Re: ITB# 2972-13: Intracoastal Waterway Force Main Replacement Project

ADDENDUM NO. 3

Re: ITB# 2972-13: Intracoastal Waterway Force Main Replacement Project

2 REVERSE DEADMAN DETAIL
SCALE: NONE

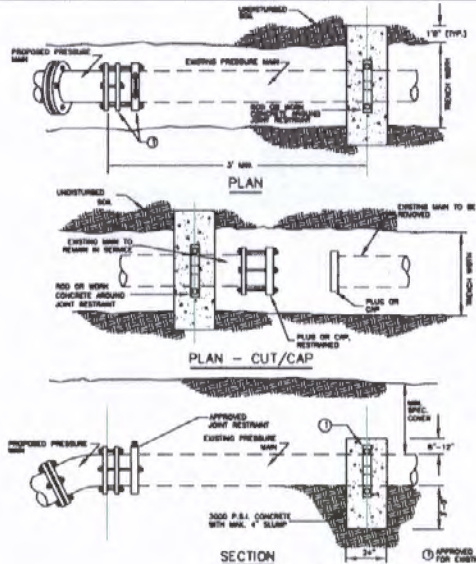
24. The same firm also asked if it was known where the existing pipe joint is relative to the location of the reverse deadman that is shown to be installed on Drawing C1.03. Mr. Truong stated that the location of the pipe joint relative to where the reverse deadman is proposed to be installed is unknown.

C1.02

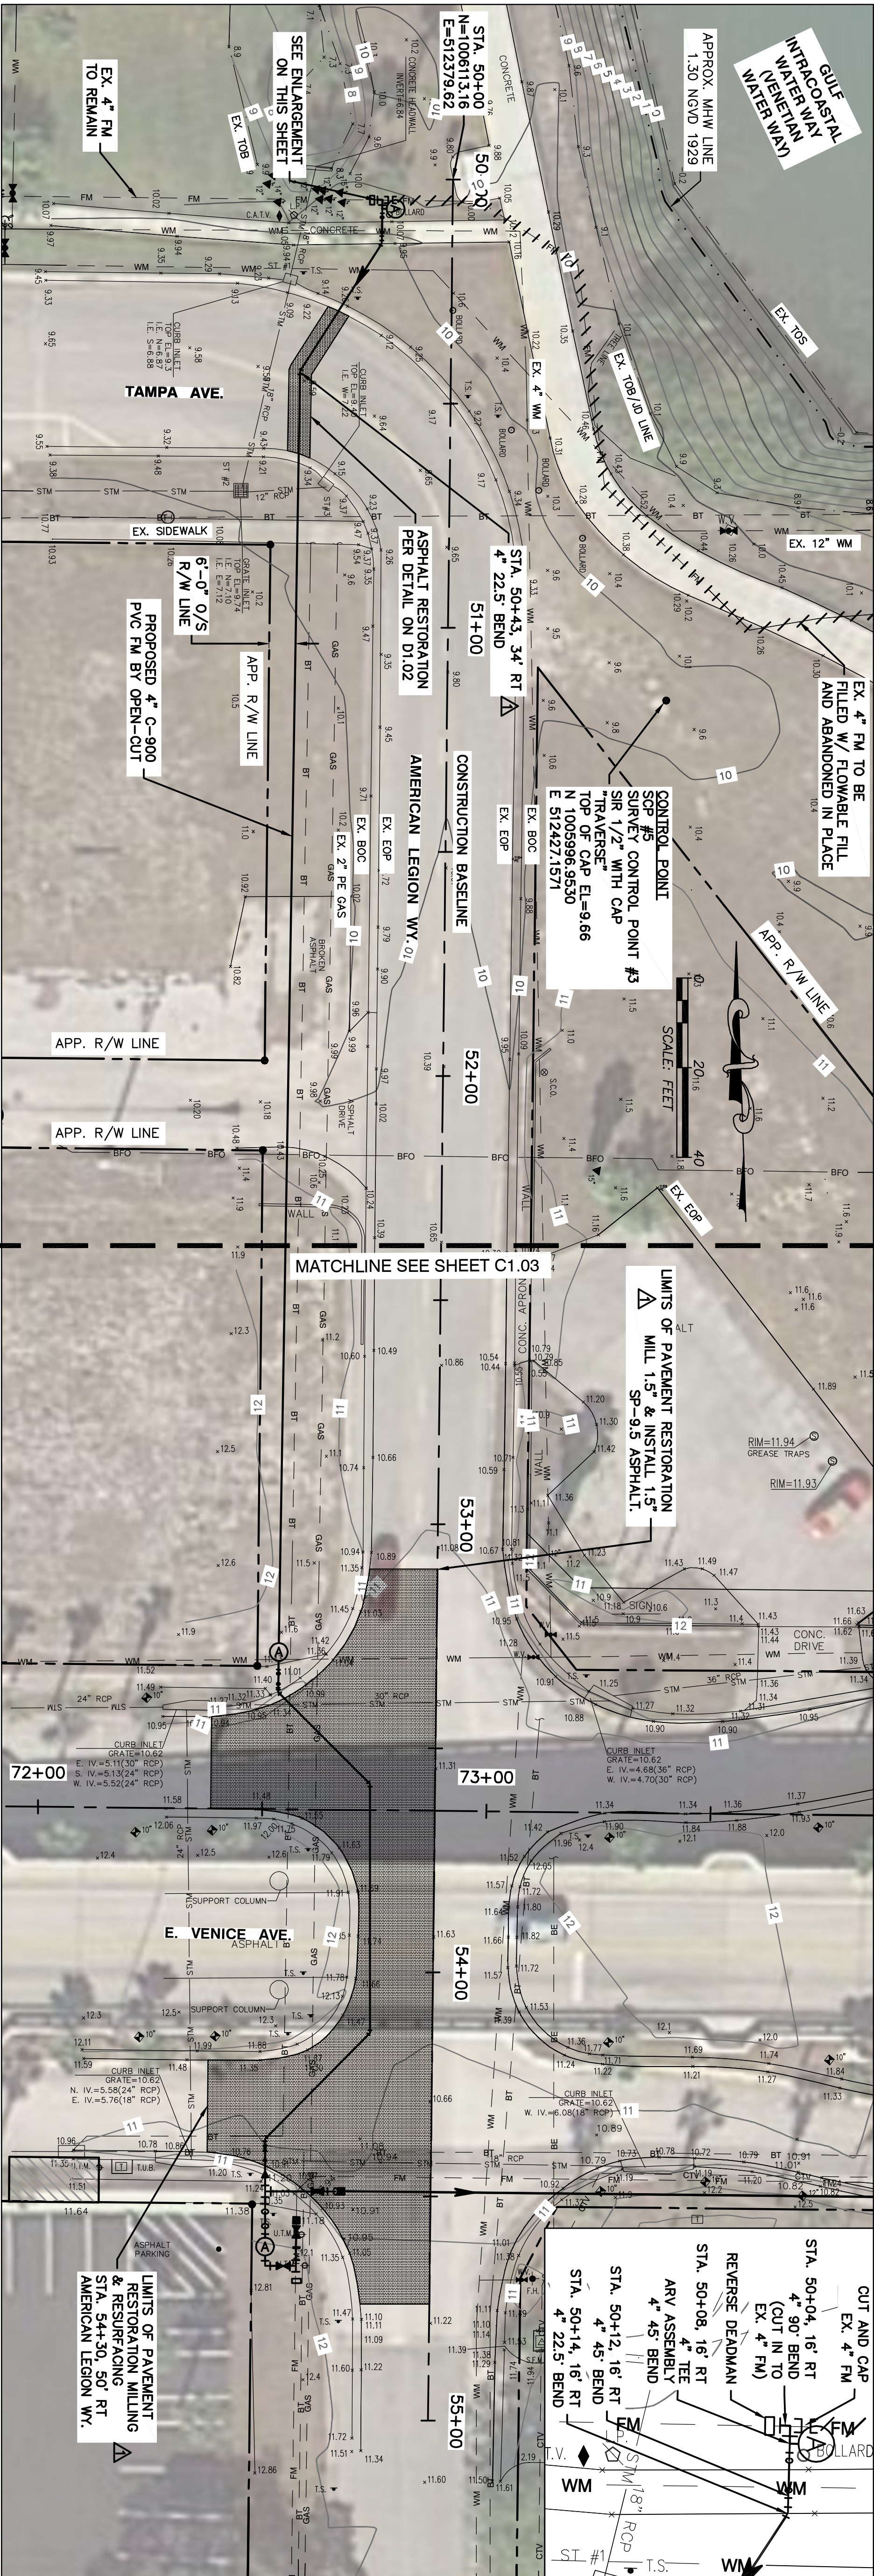
1. Drawing C1.02

Replace Drawing C1.02 with the revised Drawing C1.02.
